The Millbrook Power (Gas Fired Power Station) Order

Comments on Relevant Representations – Submitted at Deadline 2

Applicant's Comments on Relevant Representations

Deadline 2 - 17 April 2018

ADDENDUM FIGURE A1:
Viewpoint : near Amphill Park House

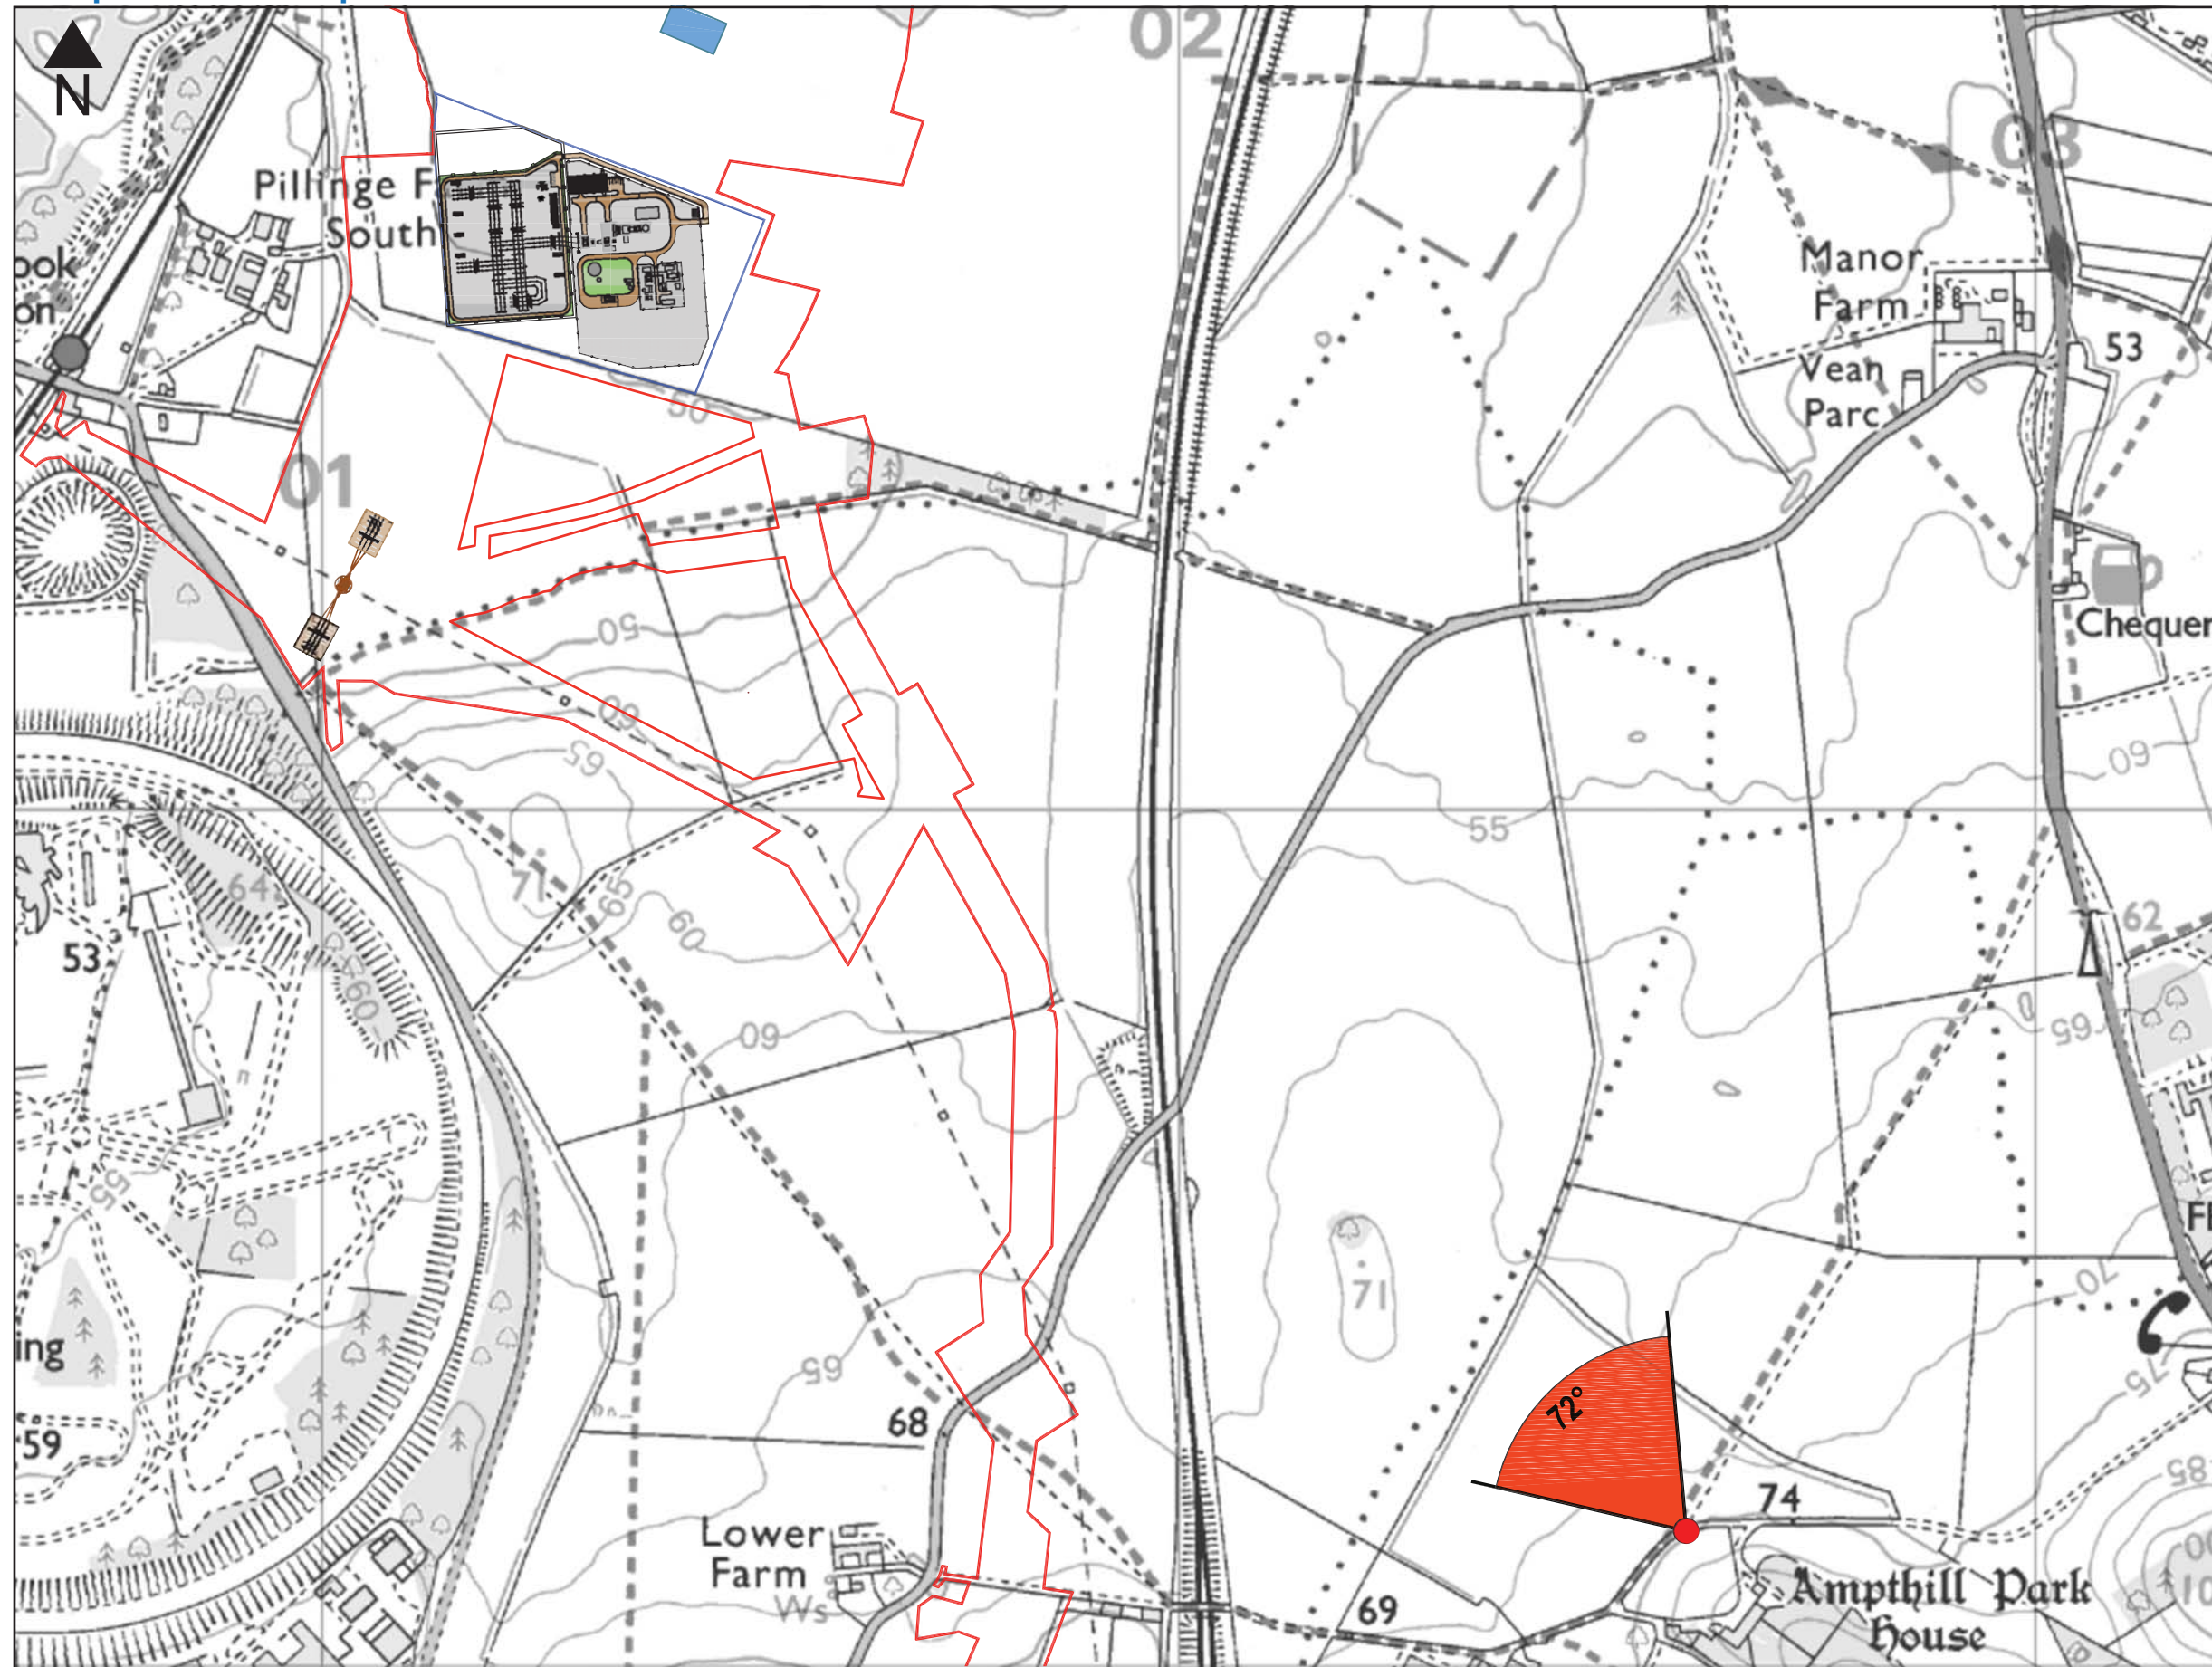
1.1 This document presents the additional designated heritage asset assessment required by Historic England. Following receipt of comments from Historic England during the late stages of the preparation of the planning application, a meeting was held with Will Fletcher (Historic England), Chris Leach (Peter Brett Associates) and Rob Bourn (Orion Heritage), to discuss the issues that Historic England had raised previously. The conclusion of this meeting was that further assessment of particular designated heritage assets, supported by some additional illustrative material, would be undertaken by Orion Heritage. The work required was as follows:

- 4.2 The photomontage demonstrates that the stack of the Project will be obscured from view at this location by a band of woodland that lies on the far side of the field immediately to the north west of the House. The new transmission tower will be visible but will be a replacement of an existing transmission tower so will be in effect be no change. Therefore, in this view, the Project will have no effect on the setting and significance of the house. The combined viewpoint with Covanta demonstrates that only the stack of Covanta will be experienced in this view and not the Project. Therefore, in this view, there will be no combined effects on the setting and significance of Ampthill Park House.

Appendix 1 Predicted Pollutant Concentration Contours

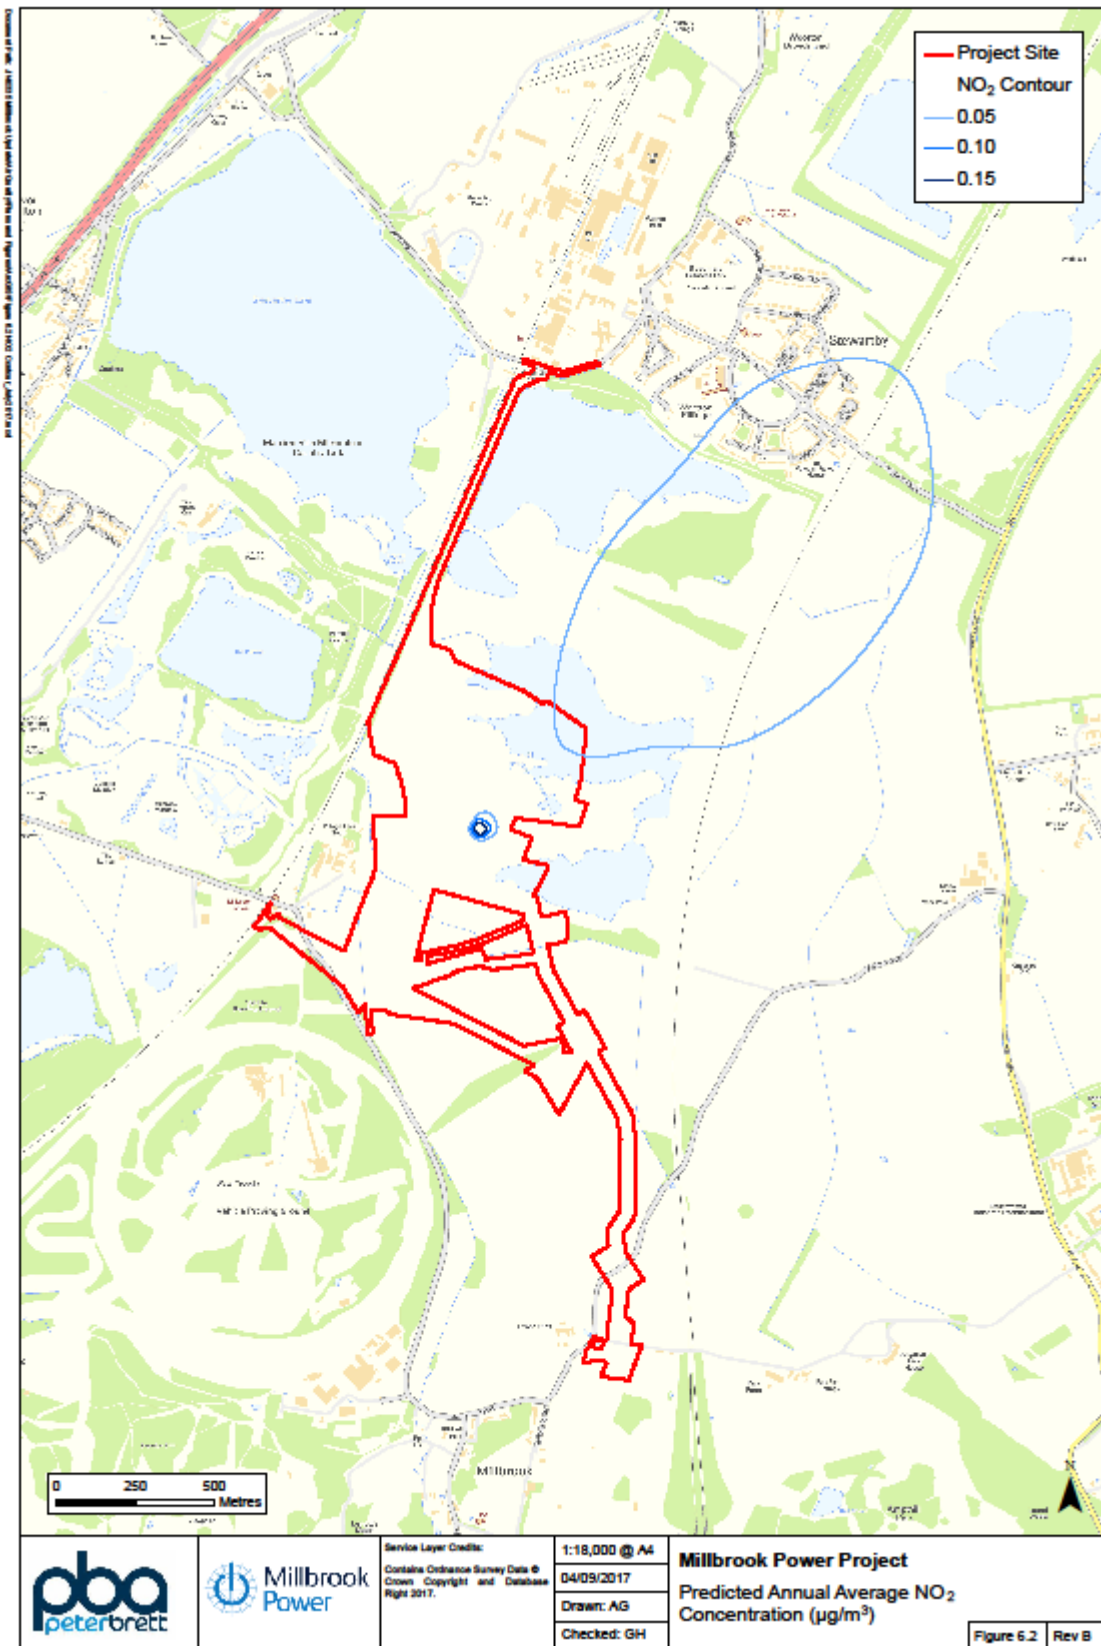
Item	Subject											
1.	<p>Introduction</p> <p>Marston Moreteyne Parish Council have raised a number of concerns regarding air quality in relation to the Millbrook Power Project in their Relevant Representation submitted to the Planning Inspectorate. Council members also asked further questions of the project team informally following the preliminary meeting on 13th March 2018. In light of this, Millbrook Power offered to meet the parish council with their air quality specialist, Graham Harker.</p> <p>This note has been put together following the meeting with the Parish Council that was subsequently held on Tuesday 3rd April in Marston Moretaine. It provides a summary of the information presented regarding the air quality assessment for the development, a full report on which can be found in Chapter 6 of the Environmental Statement submitted with the application.</p>											
2.	<p>Emissions and Assessment Criteria</p> <p>The combustion process will lead to the release of two pollutants: oxides of nitrogen (NO_x) and carbon monoxide (CO). NO_x is a combination of two gases: nitrogen monoxide (NO) and nitrogen dioxide (NO₂). Of these, NO is effectively harmless and the main concern regarding the potential for health impacts concerns NO₂. The NO_x release will primarily be NO, with a small proportion of NO₂. However, NO oxides in the atmosphere to form NO₂ and this is taken into account in the impact predictions.</p> <p>The concentration of the pollutants in the exhaust gas is limited to values set in the Industrial Emissions Directive (IED). The maximum concentrations for NO_x and CO are 50 and 100 mg/m³ (milligrams per cubic metre). Once released from the stack, the pollutants disperse in the atmosphere, increasing the ambient concentrations of pollutants.</p> <p>The limits for the concentrations of pollutants in the atmosphere are set in the Government's National Air Quality Strategy. The limits are set on the basis of protecting the health of the public. The relevant concentration limits in the atmosphere to protect human health are shown below in units of microgrammes per cubic metre.</p>

6.	<p>Interaction with Covanta</p> <p>It should be recognised that the design and operation of the two facilities have some fundamental differences:</p> <ul style="list-style-type: none"> • Covanta is designed to operate continuously for most of the year whereas Millbrook will operate intermittently for a limited number of hours • The stack heights for the two facilities are significantly different; 32.5 metres for Millbrook and 105 metres for Covanta. This stems from the relative pollutant release rates that need to be dispersed, the difference in operating hours and the difference in emission characteristics between the two plants (Covanta has a much lower discharge temperature and discharge momentum). • The differences in stack heights means that the location of the maximum ground level concentrations will be different, and there will be limited interaction between the discharge plumes. <p>Nevertheless, the cumulative impact of Millbrook and Covanta operating together has been assessed by running a dispersion model containing the emissions from both plants. The concentrations at selected human health and ecological receptor locations were predicted. As anticipated, (as the impact from Millbrook is insignificant on its own), the majority of the total predicted concentration stems from the contribution from Covanta. When taken together, the predicted concentrations at the selected human health receptor locations remains well below the limit values. The impacts at the ecological receptors are not significant.</p>

7.	<p>Operational Controls</p> <p>There are two sets of controls on the proposed development; planning permission is needed to construct the facility (via the DCO process) and an Environmental Permit is required to operate the facility (via the Environment Agency). In both cases, the applications are subject to independent scrutiny.</p> <p>In the case of the Environment Agency, they are required to ensure that emissions from the facility do not breach the agreed emission limits and that it is operated in a manner that does not have significant impacts on the environment.</p> <p>During operation, the emissions from the exhaust stack will be continuously monitored (by the Operator) to ensure that the emission limits are not breached. The Environment Agency will audit the information to ensure that this is the case.</p>
